**Basement Impact
Assessment Audit**

12 Park Village West, London
NW1 4AE

For
London Borough of Camden

Project No.
14006-88

Number: 21-08-701 Rev: P01

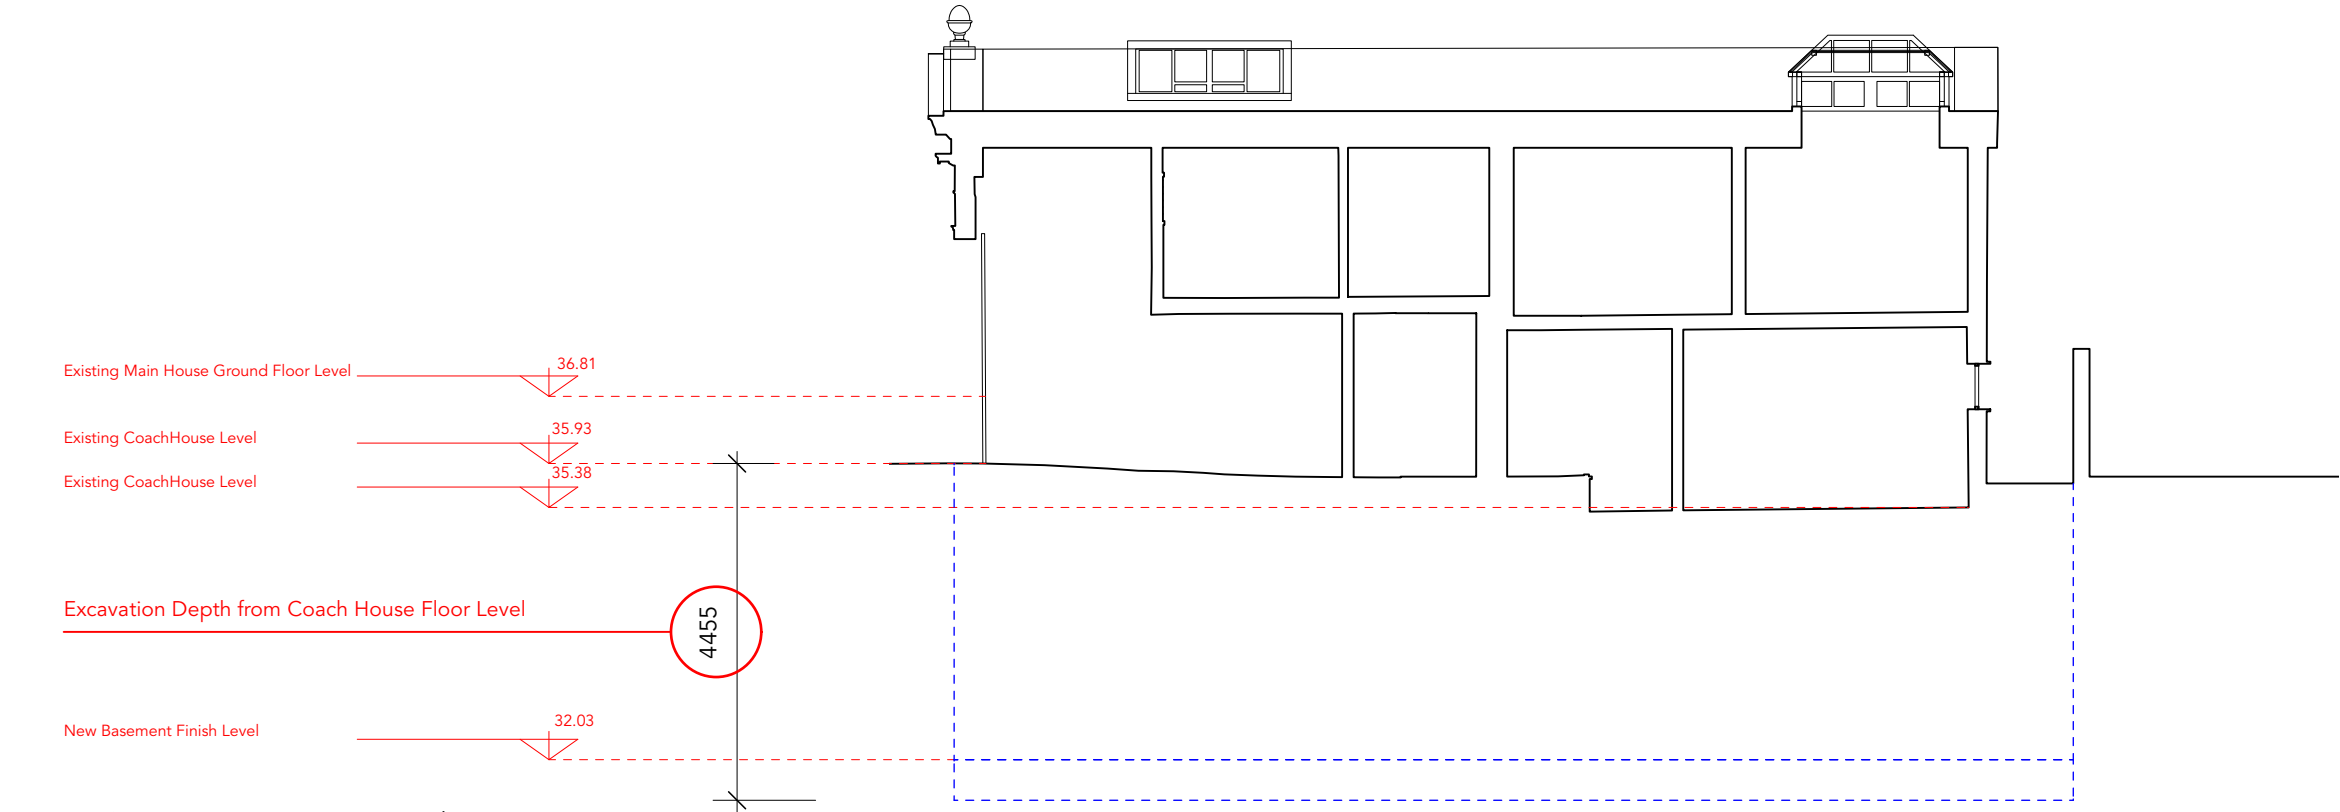
- 4.18 Stability Screening Assessment identifies sloped ground $>7^\circ$ in the eastern part of the site and in the wider area however, the basement is in the western part of site is remote from these features. The revised submission includes a topographic survey drawing to verify the site levels.

- 5.7 The development is located near the crest of a slope although the basement excavation is remote from the sloped area. The revised submission includes a topographic survey drawing to verify the development will not impact slope stability of the site and neighbouring properties.

Query No	Subject	Query	Status	Date closed out
1	Stability	Include the topographic survey drawing to support conclusions regarding slopes	Closed – paragraph 4.18	November 2024
2	Stability	An engineering statement, construction method and outline structural engineering information should be provided	Closed – paragraph 4.5	November 2024
3	Stability	Drawings of the construction sequence and propping arrangements should be provided	Closed – paragraph 4.5	November 2024
4	Stability	The form of construction must be confirmed to verify the GMA conclusions	Closed – paragraph 4.5 & 4.23	November 2024
5	Stability	The depth of excavation must be confirmed to verify the GMA conclusions	Closed – paragraph 4.23	November 2024

Number: 21-08-700 Rev: P01

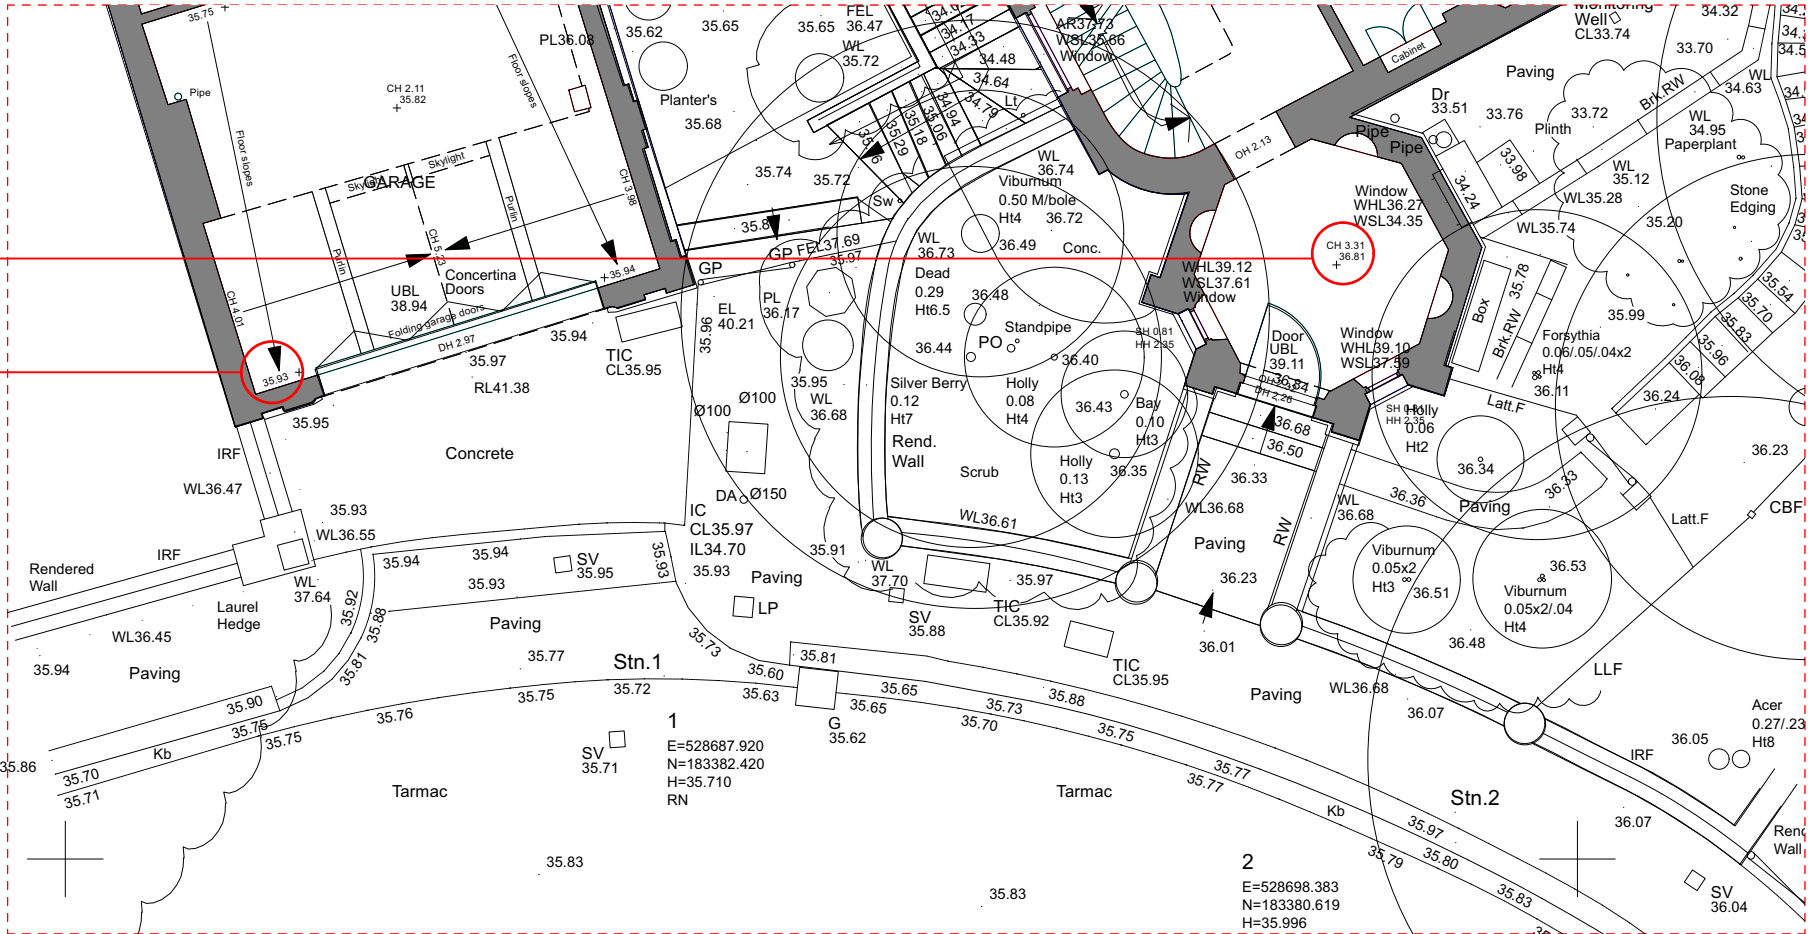
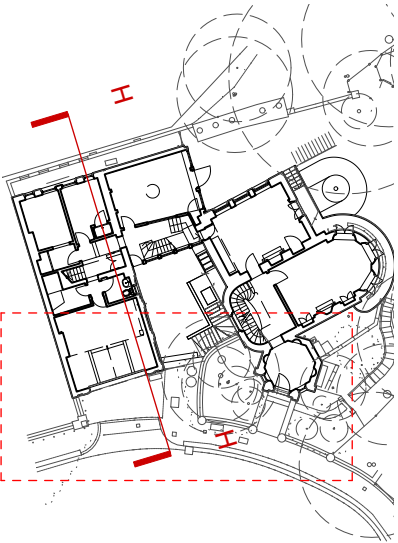
- 4.4 The proposed basement floor level is not uniform. It is deepest beneath the Coach House and shallower beneath the link building and main house. Email correspondence with the Camden Planning Officer indicates the lowest proposed floor level is +32.03m AOD equivalent to 4.78m bgl at the Coach House (Appendix 3). Section DD drawing illustrates the basement level beneath the main house and new link building is c.1.70m above the Coach House basement floor.
